**Briargate Bridge at Sand Creek
Design Report
Sand Creek Drainageway**

Kiowa Project No. 19032

April 29, 2022

CDR-21-013

Bending moment(lb-in/in): Load steps 1,2,3,4,5,6,7,8,9,10,11,12,13,14,15,16,17,18,19,20,21,22,23,

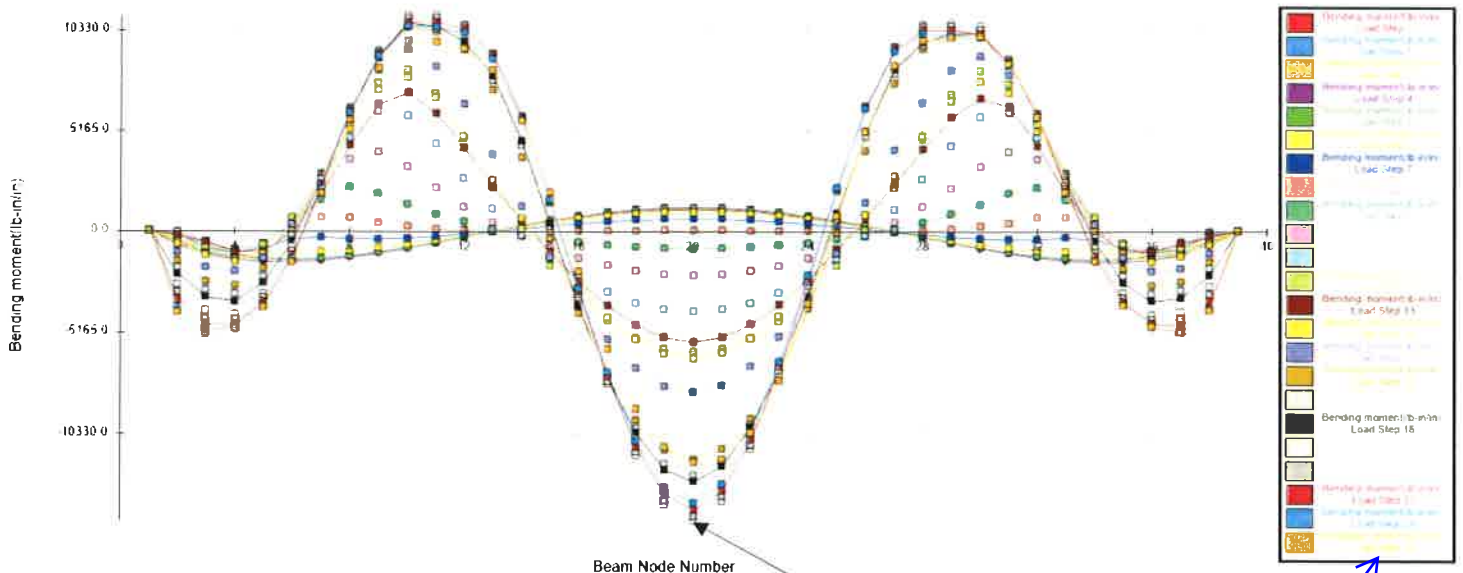
This is not legible -
please provide a
better copy
